SERVICE BULLETIN 111405

AIRCRAFT AFFECTED: ALL SUPER REBEL AND MOOSE

SR3500 TAIL MODIFICATION

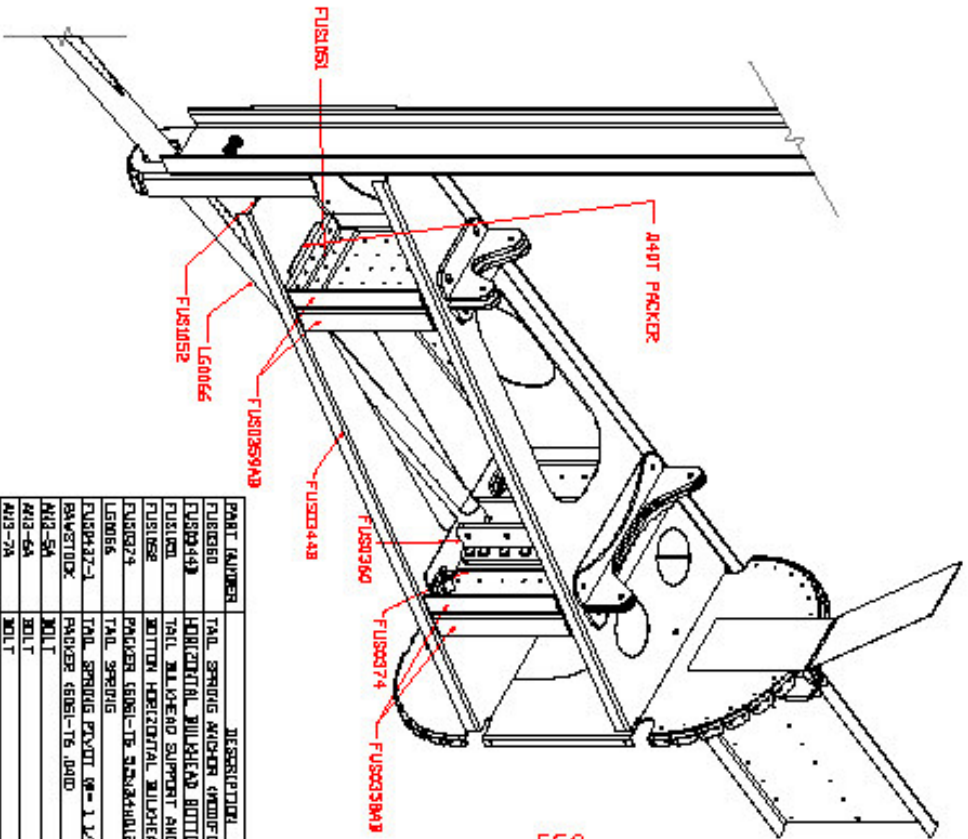
There is now a recommended tail modification available for all Super Rebel and Moose models. See diagram outlined on next page.

It consists of parts designed to “box in” the tail spring mounting area of the rear tail section. Parts and prices listed in the attached drawings.

The new solid LG0066 1 1/16” diameter, tapered, milled, formed and tempered tail spring allows much more flexibility and reduces the loads in the tail area but does require the modified 1 1/16” FUS437-1 Tail Spring Pivot.

The original LG0065 1” tail spring is adequate provided a 14” long piece of 5/8” diameter solid tempered steel is inserted inside of the LG0065.

The 14” X 5/8” steel insert must be centered at the tail spring pivot and prevented from sliding down by installing a piece of 5/8” diameter aluminium tubing below the insert.

Install both parts wet with two part epoxy zinc chromate.

NOTE; In order to maintain the maximum strength and rigidity of the original 1” LG0065 tail spring; it **MUST** be mounted with the bow at the top, or the top of the arch up.
